FILE REF.: CASE # V 17-5030 St. Francis South Variance

Vegas Verdes LLC, Applicant, Jenkins Gavin, Inc., Agent, is requesting a variance of the Sustainable Land Development Code Chapter 7.11 Road Design Standards, Table 7-12 Urban Road Classification and Design Standards (SDA-1) to allow a right-of-way width of 65 to 70 feet in different locations rather than the 120 feet of right-of-way as required in Table 7-12 which classifies the interior loop road as a minor arterial.

ROAD VARIANCE SUBMITTAL FOR ST. FRANCIS SOUTH

TYPICAL SECTIONS

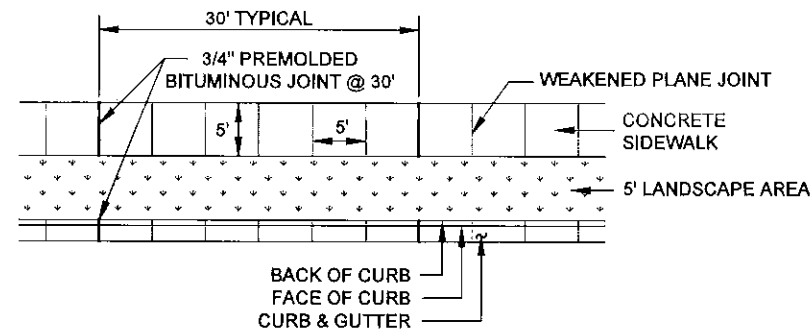
Table 7-12 classifies the loop road as a Minor Arterial due to the average daily traffic of 2000 to 4999 trips. The road serves only the traffic generated by this development which would not warrant a 4-lane road, therefore, a 120' wide right of way is not needed.

A 120' wide right-of-way is required by Table 7-12. With a two lane road, curb and gutter, sidewalks and bike lanes meeting the design standards of Table 7-12, a 70' right of way should be adequate.

The subject road is an internal loop road that provides access to this development/subdivision only. A two-lane road with curb and gutter, sidewalks, and bike lanes meeting the standards of Table 7-12 will be sufficient to serve the development. Therefore, a 70' right of way is sufficient.

1. Right of way width shall be a minimum of 70'.
